BW Project No.:	24-09-136
BW Project Title:	DPW #25252 University of Idaho Project: North Campus Entrance Hwy-8
Client:	DPW & University of Idaho
Date:	03/13/2026
Addendum #:	001

This addendum consists of a total of 36 pages and including 5 drawings and listed attachments.

F. CHANGES TO DRAWINGS

Cover Sheet
G0.00

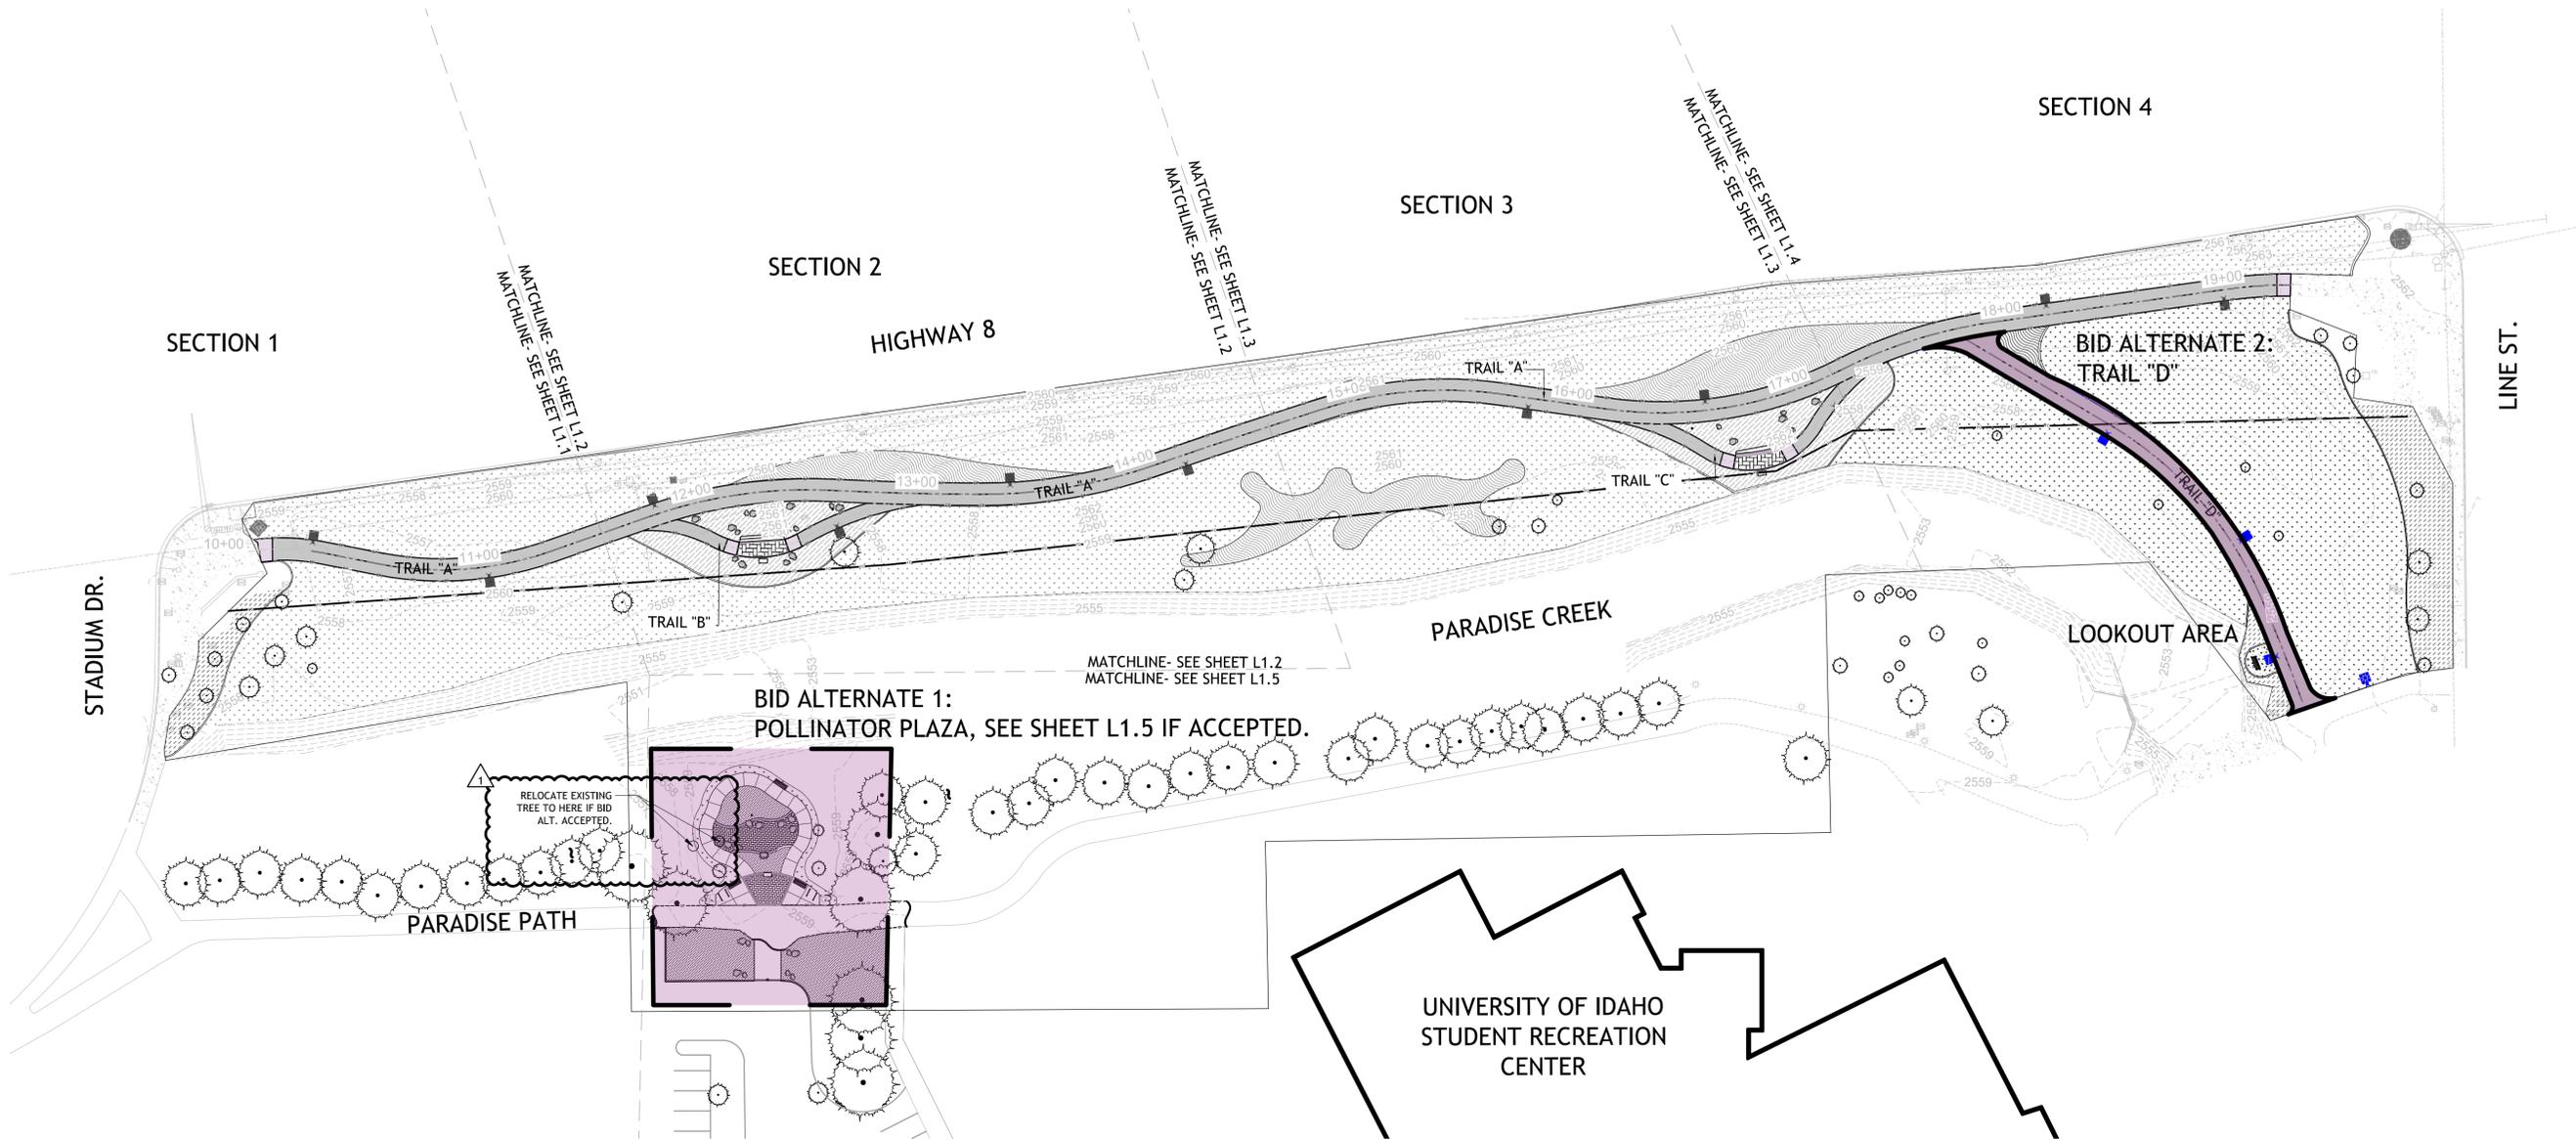
1. Cover

- a. Delete "Gravel Path" under Bid alternate #2. Base Bid included final grading and hydroseeding only in this area (No Gravel Path or Lights).
- 2. Sheet G1.1
 - a. Bid Alternates- clouded revision of moving an existing tree be relocated by contractor outside.
- 3. Sheet L1.6 Materials Plan- Trail 'A' Sec 4, Alt 02: Trail 'D'
 - a. Callouts added, Materials Schedule modified.
- 4. Sheet L1.7
 - a. Reissue: Sheet L1.7 Materials Plan- Bid Alternate 01 Pollinator Plaza
 - i. Scale Bar modified only, (scale is correct with naming convention under sheet title, Existing Tree to Move Into exterior of Hardscape.
- 5. Reissue L2.6
 - a. Sheet L2.6 Planting Plan- Trail "A" Sec 4, Alt 02: Trail 'D'
 - i. Boundary of Alternate 02 is placed to show plantings, overlook garden are a part of bid alt.

- 8. Sheet G0.00 Cover Sheet
 - a. Bid Alternate Sections: Alternate 2 Modified
- 9. Sheet G1.1 Bid Alternates
 - a. clouded revision of moving an existing tree to the outside limits of the hardscape.

MATERIALS
 PLAN- TRAIL 'A'
 SEC 4, ALT 02:
 TRAIL 'D'

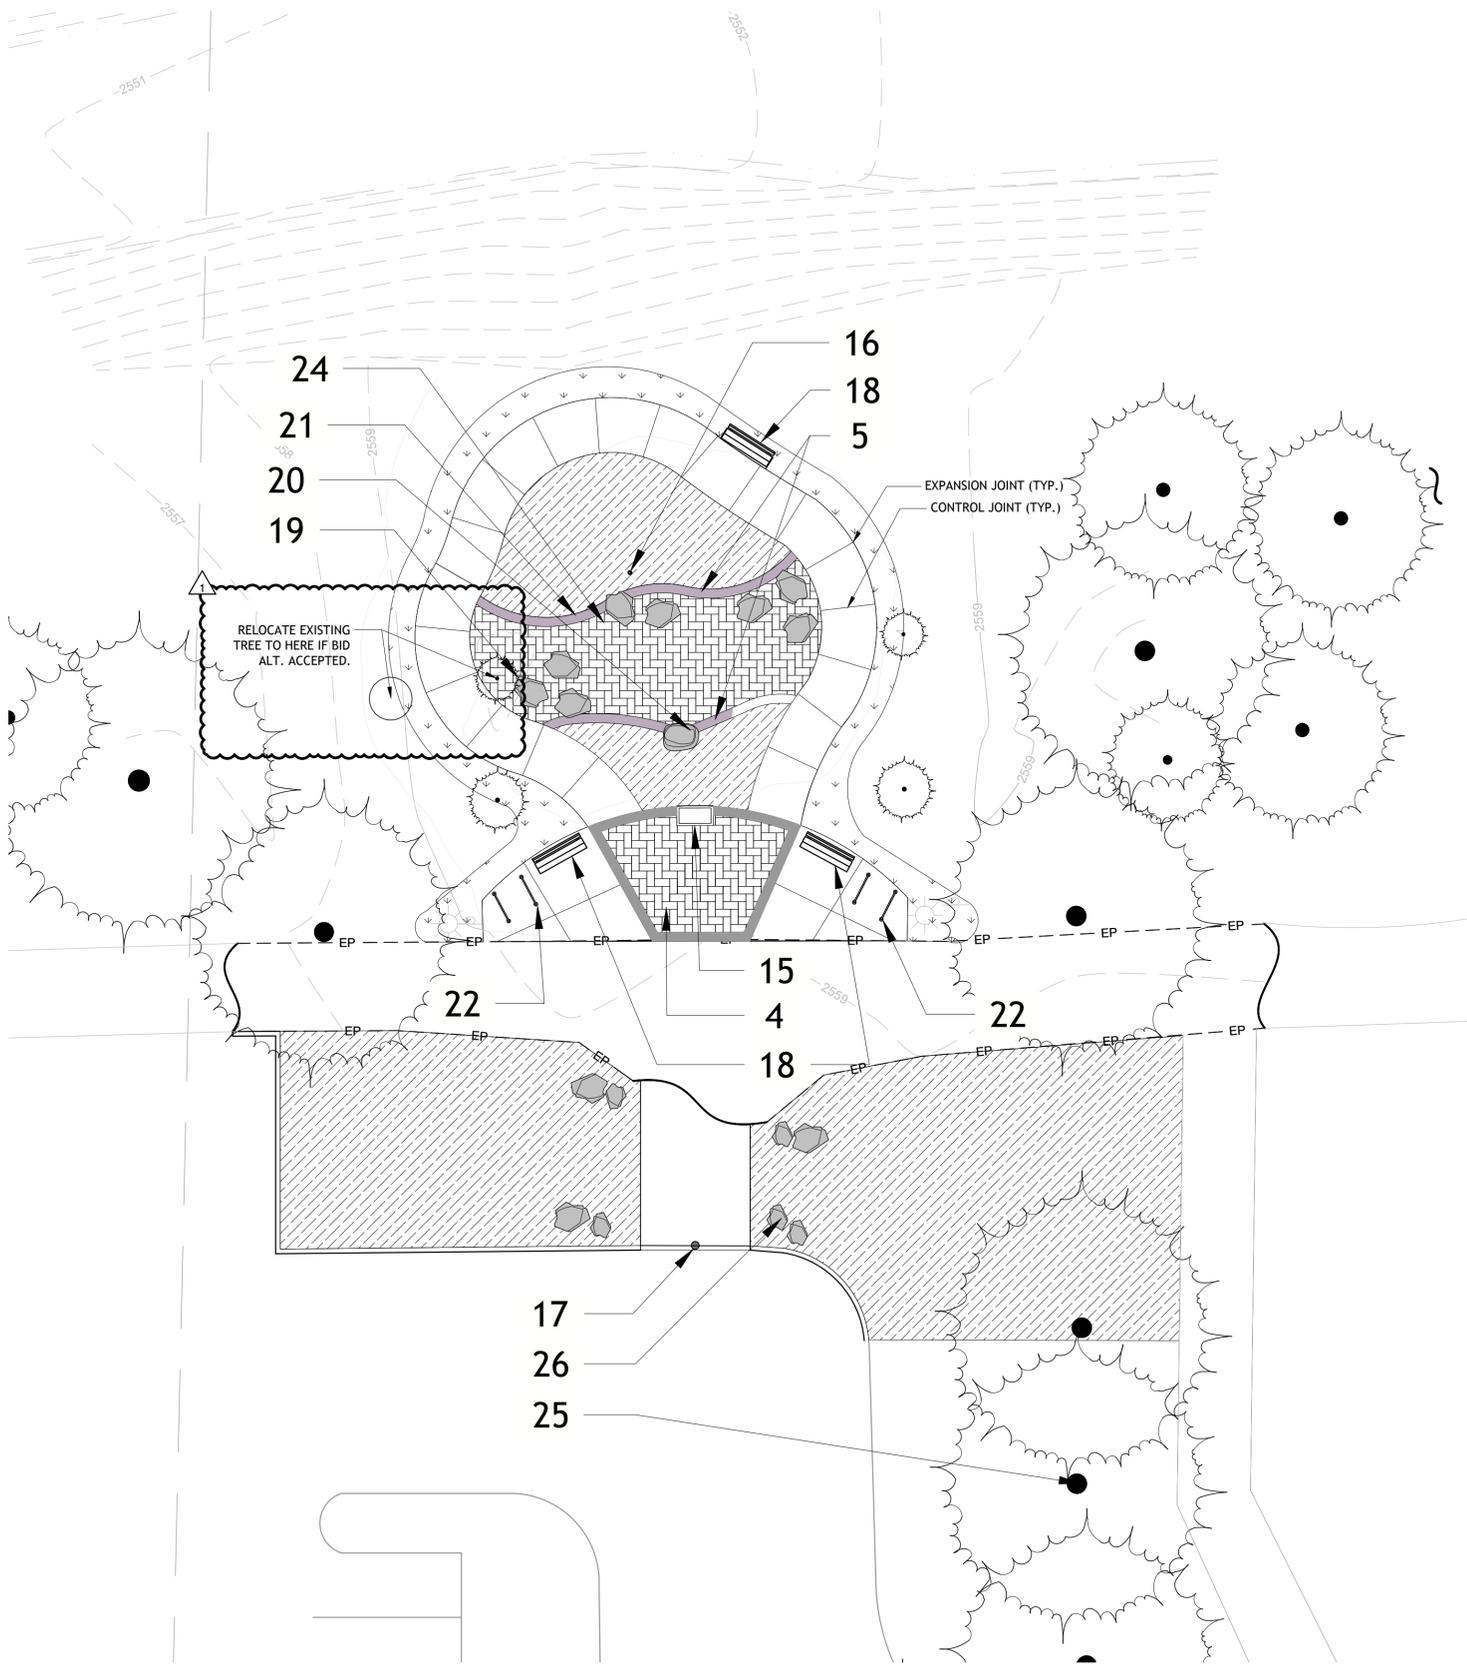
- 10. Sheet L1.6 Materials Plan- Trail 'A' Sec 4, Alt 02: Trail 'D'
 - a. Callouts added, Materials Schedule modified to reflect items that were missed by LA.

**MATERIALS PLAN-
BID ALTERNATE 01
POLLINATOR
PLAZA**

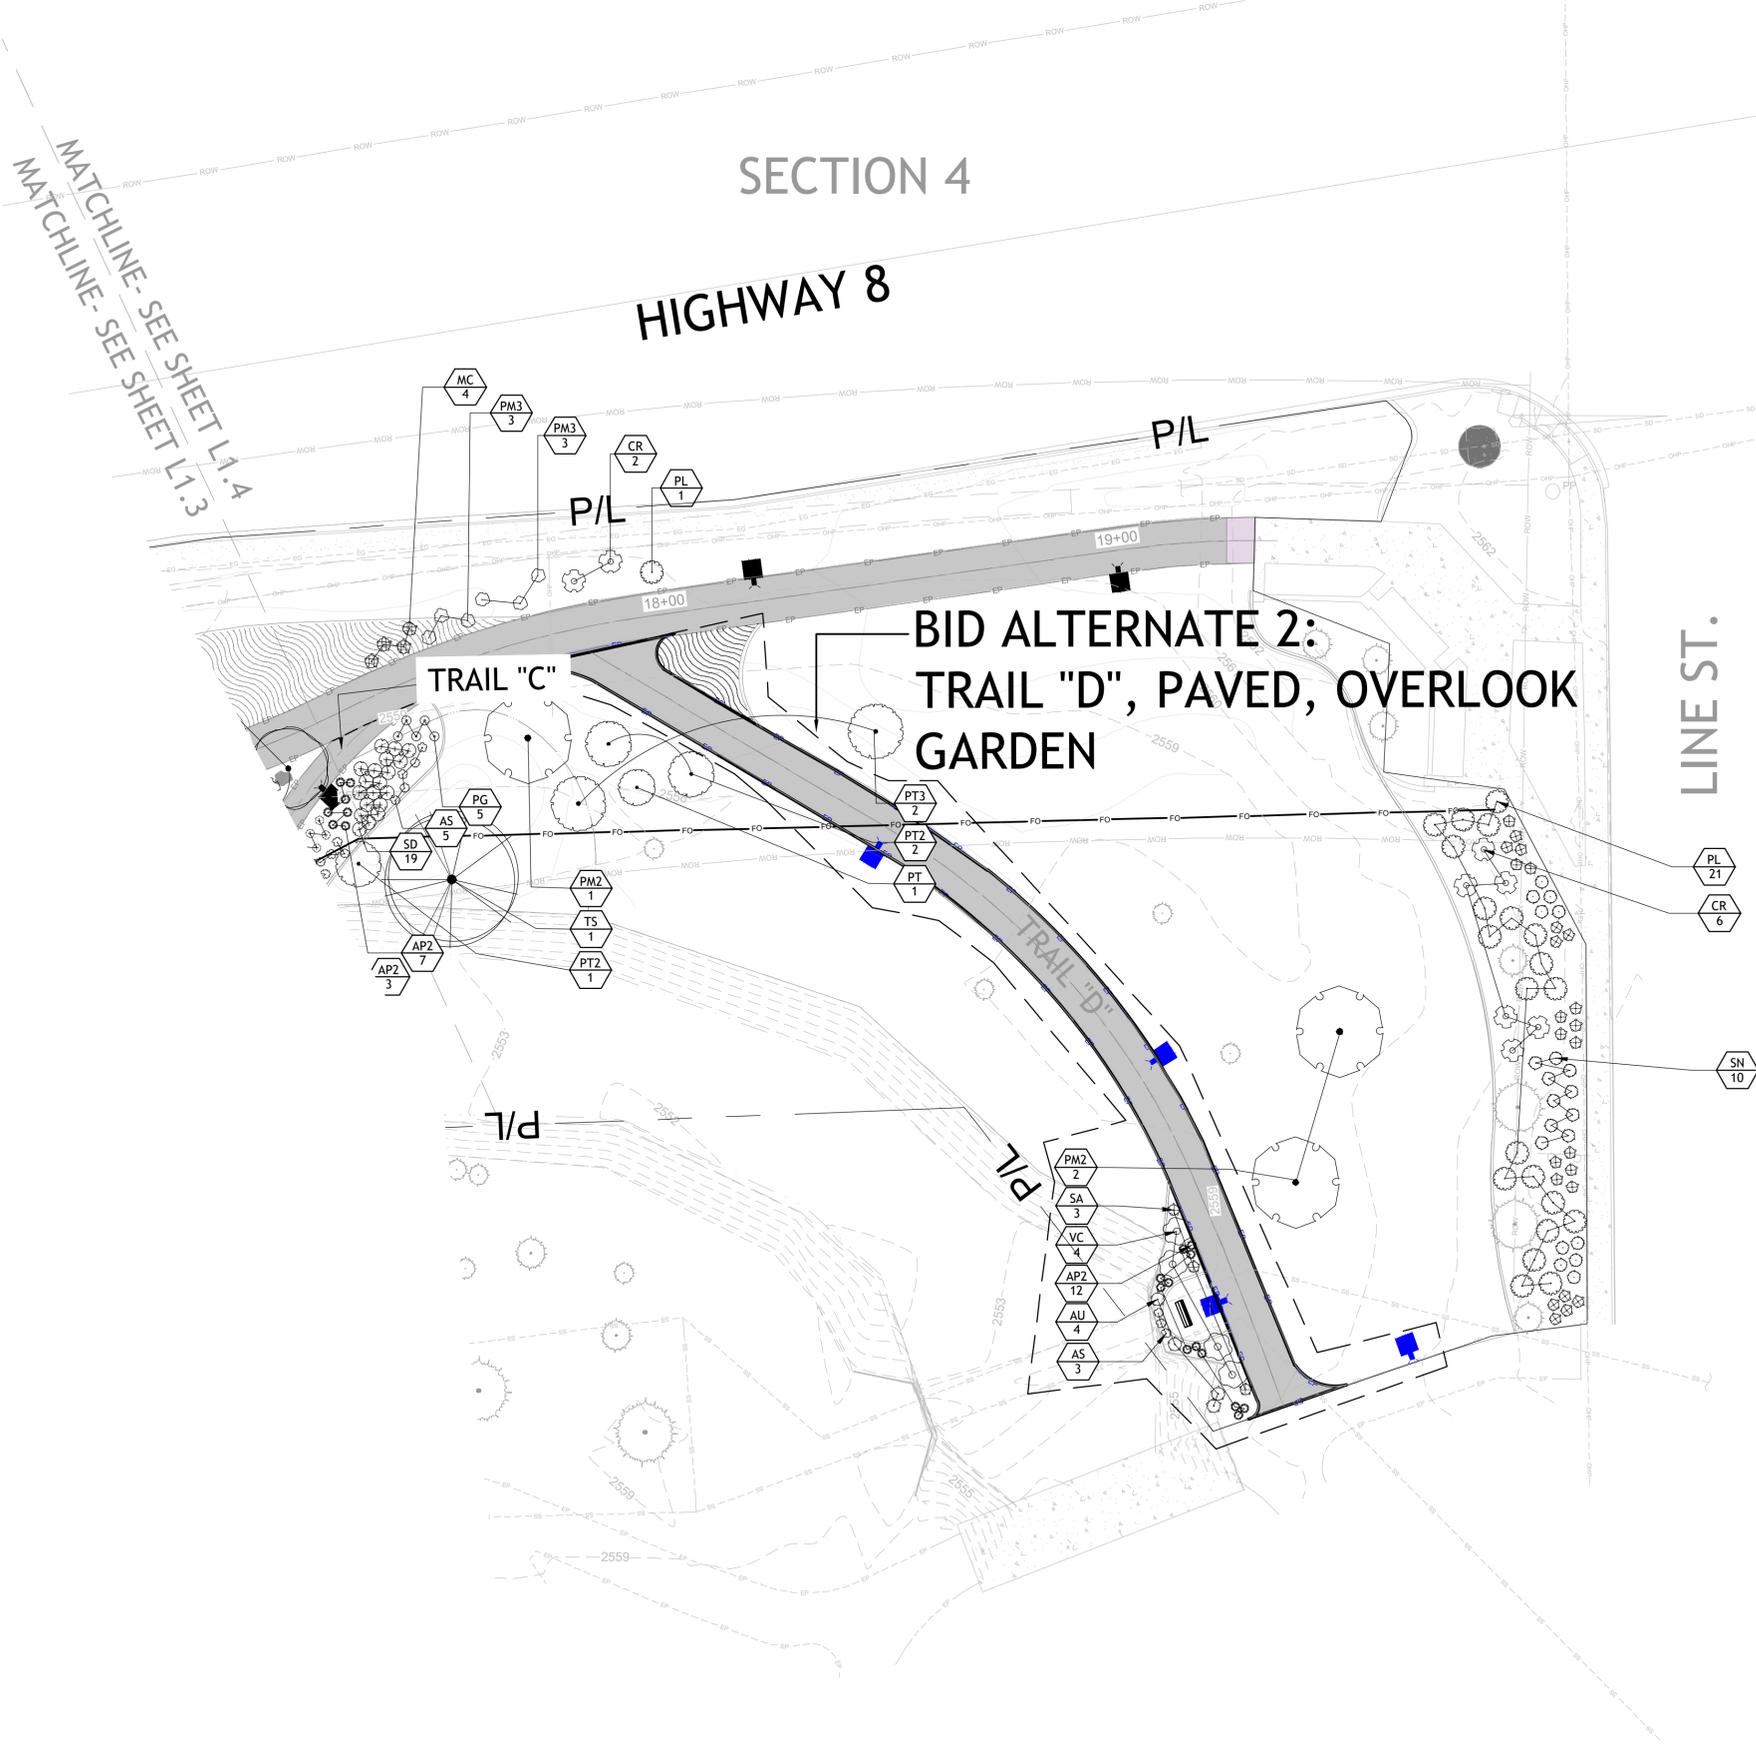
- 11. Sheet L1.7 Materials Plan- Bid Alternate 01 Pollinator Plaza
 - a. Scale Bar modified only, (scale is correct with naming convention under sheet title, Existing Tree to Move Into exterior of Hardscape.

TRAIL "D": MATERIALS PLAN : ALT 2 PAVED
W/LIGHTS

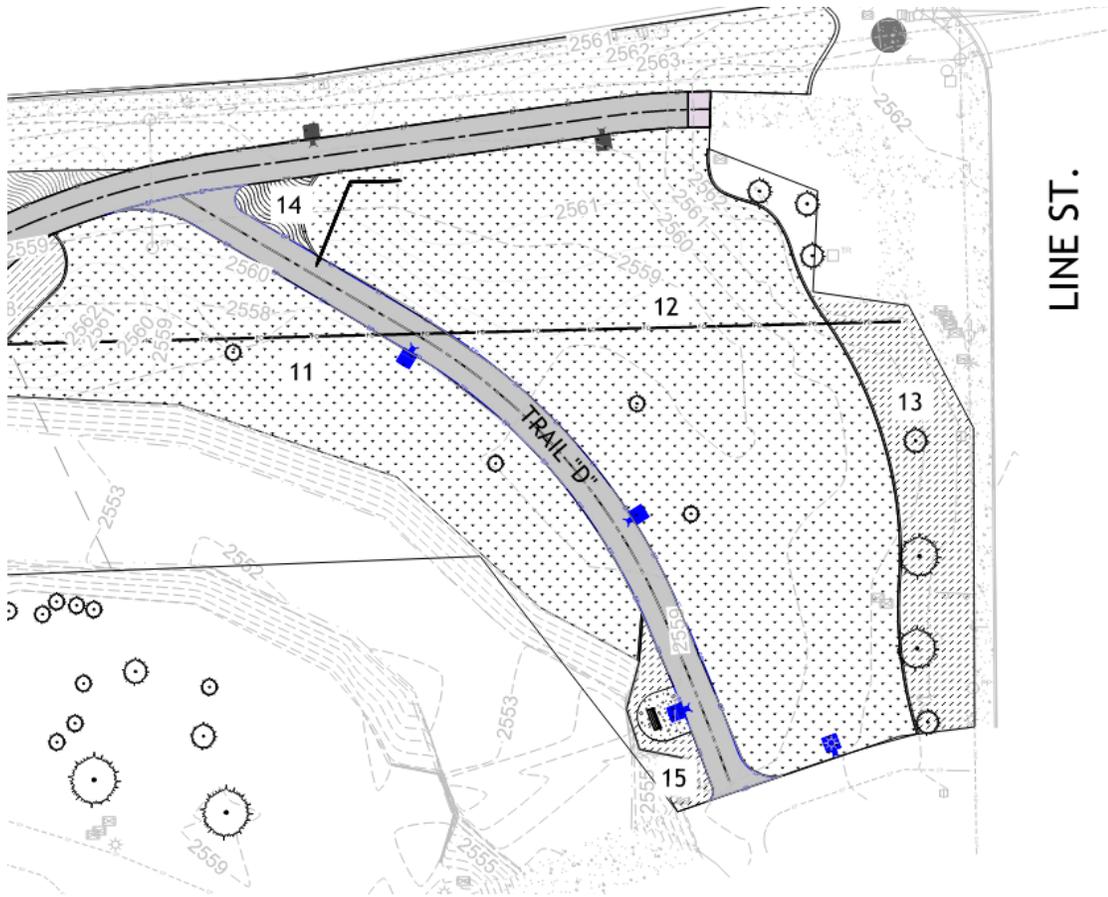
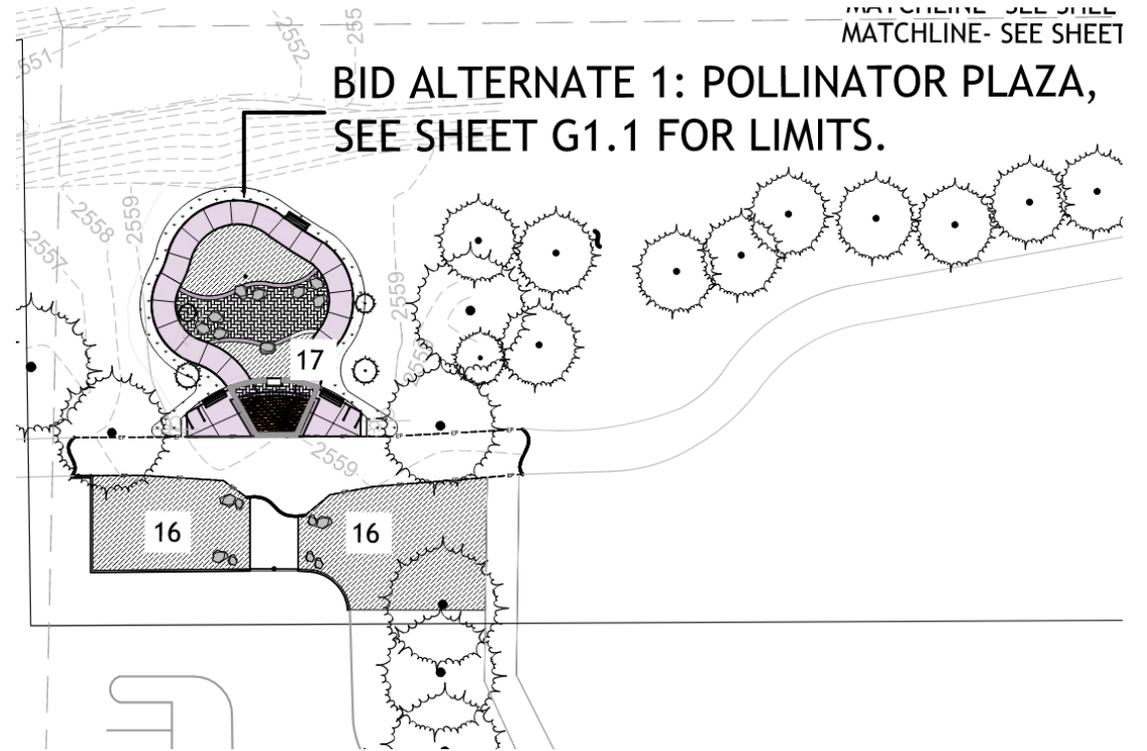
TRAIL "D": MATERIALS PLAN : ~~BASE BID GRAVEL~~
NO WORK IN THIS AREA
